FAIRFIELD UNION MIDDLE SCHOOL & US RT 22
WIDENING

Environmental
Protection Agency

Re: Coughlin Automotive - Circleville, Pickaway County

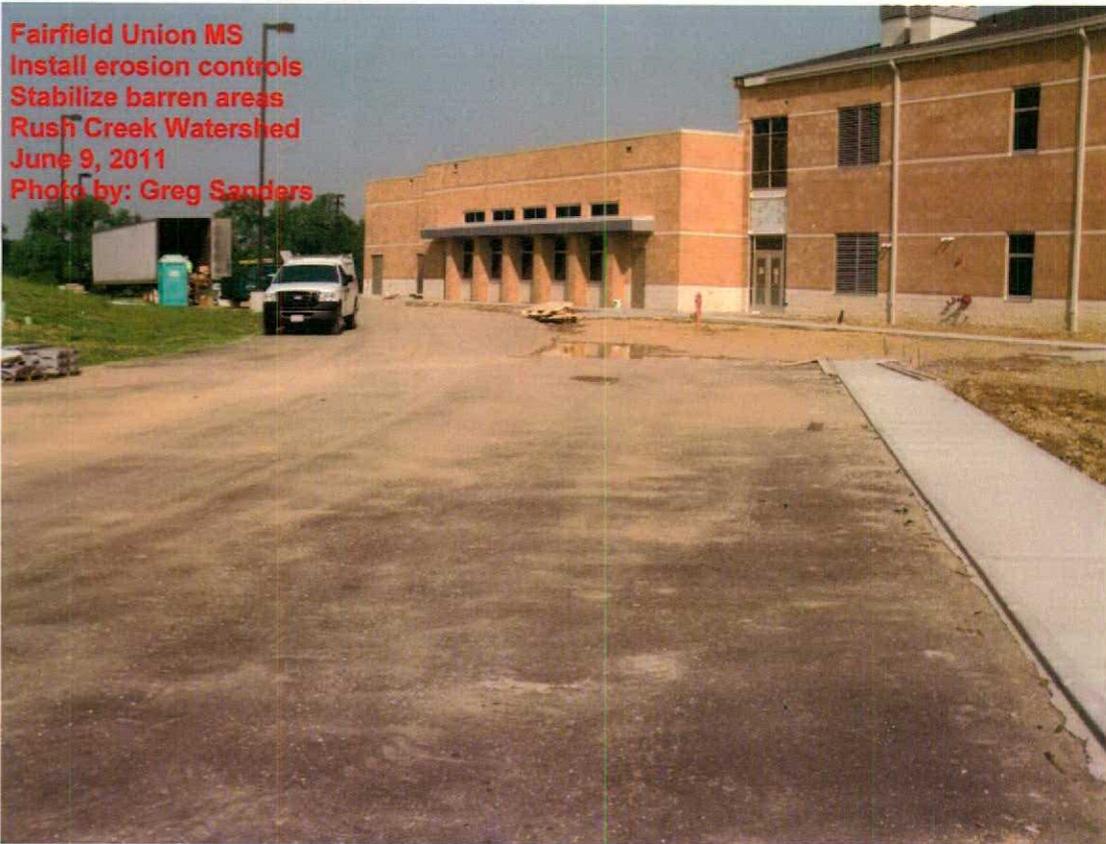
Fairfield Union MS
Install erosion controls
Stabilize barren areas & ditch
Rush Creek Watershed
June 9, 2011
Photo by: Greg Sanders

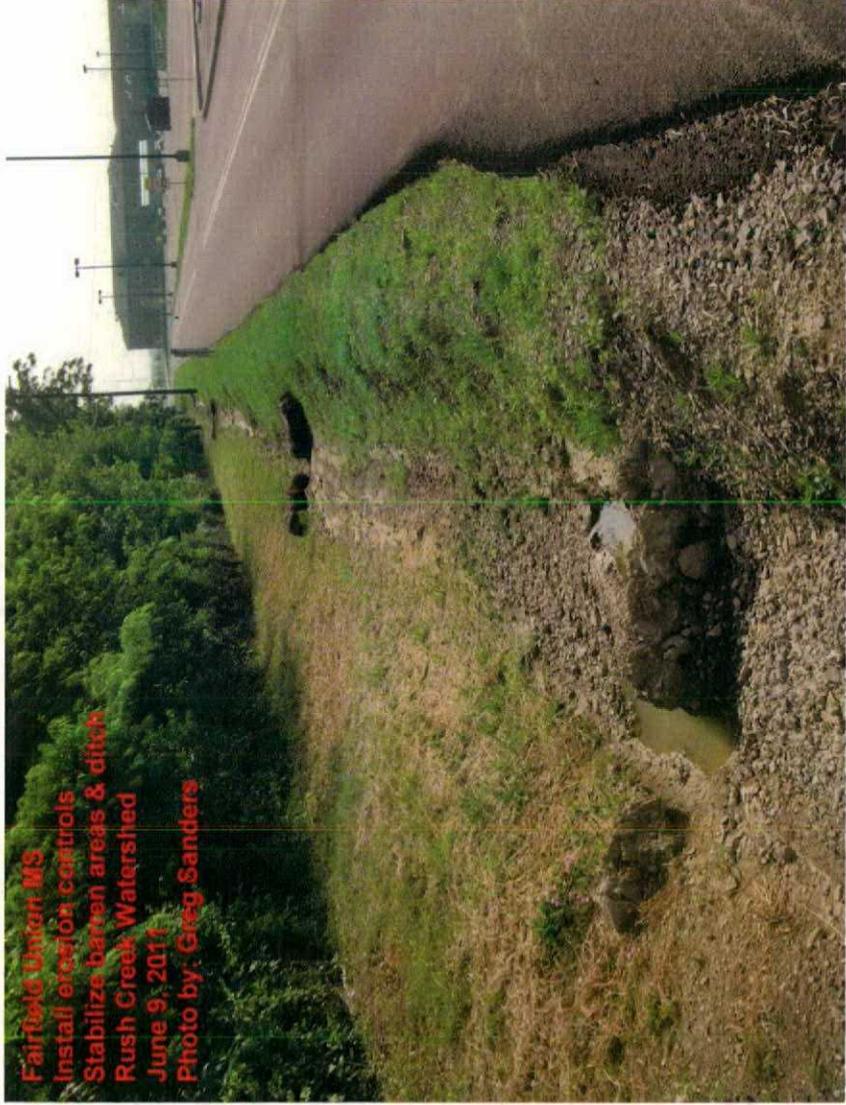
Fairfield Union MS
Install erosion controls
Stabilize barren areas
Rush Creek Watershed
June 9, 2011
Photo by: Greg Sanders

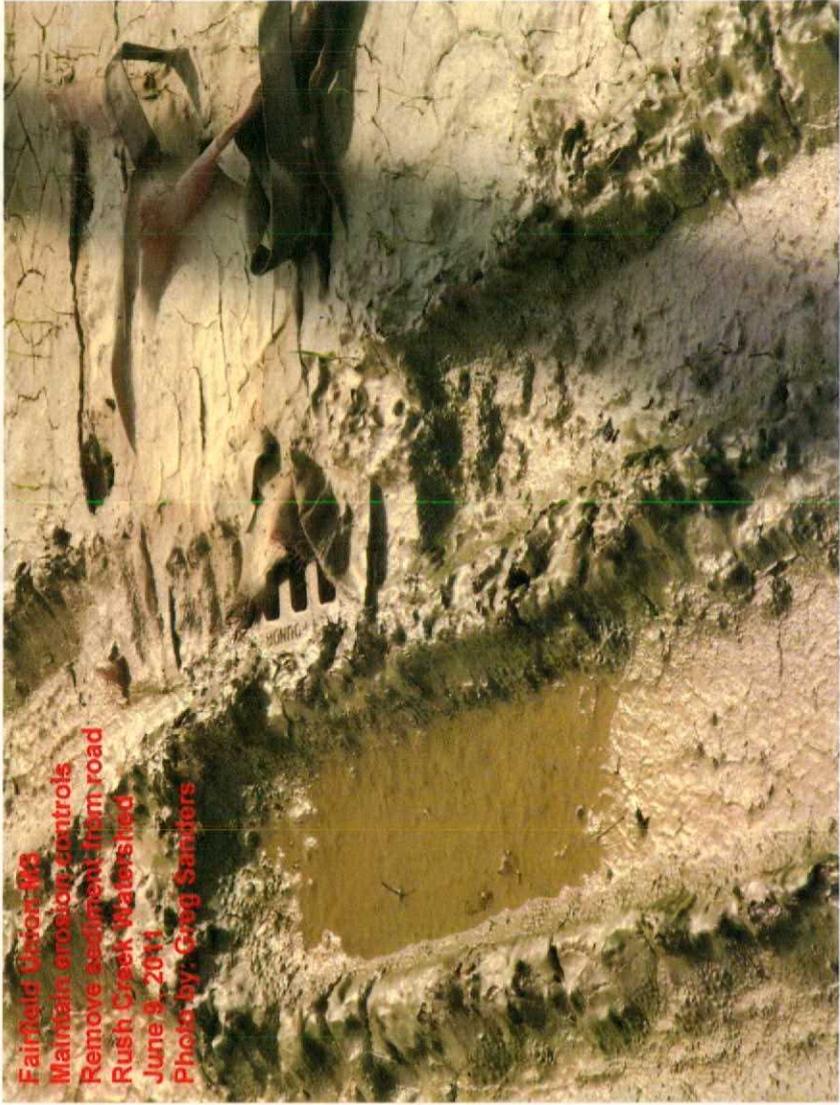
Fairfield Union MS
Install erosion controls
Stabilize barren areas & ditch
Rush Creek Watershed
June 9, 2011
Photo by Greg Sanders

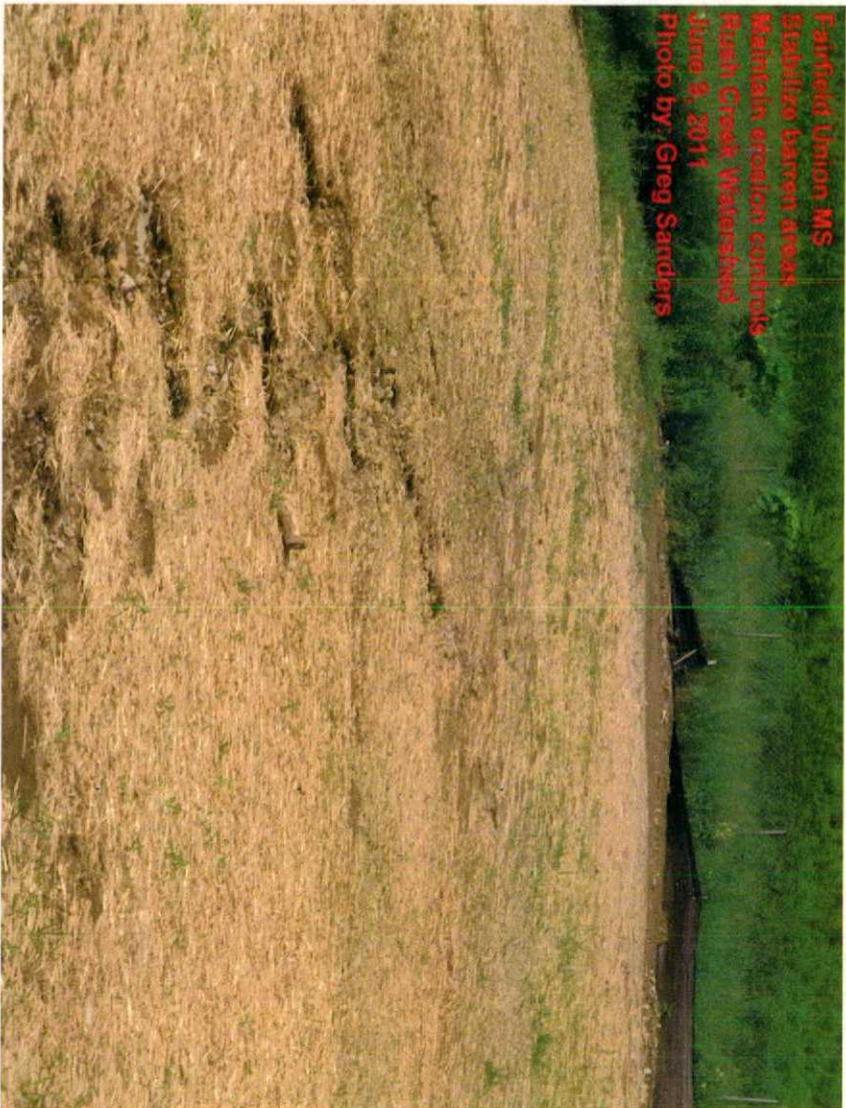
Fairfield Union MS
Maintain erosion controls
Remove sediment from road
Rush Creek Watershed
June 9, 2011
Photo by Greg Sanders

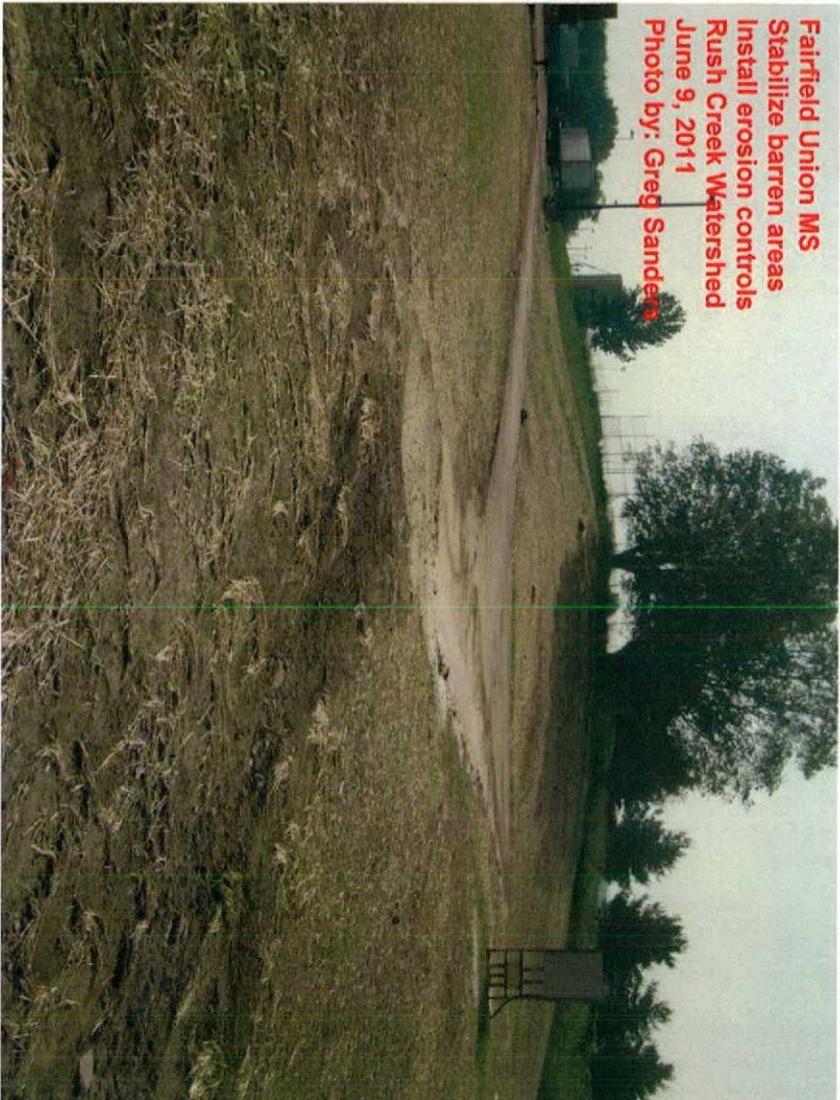
Fairfield Union MS
Stabilize barren areas
Maintain erosion controls
Rush Creek Watershed
June 9, 2011
Photo by: Greg Sanders
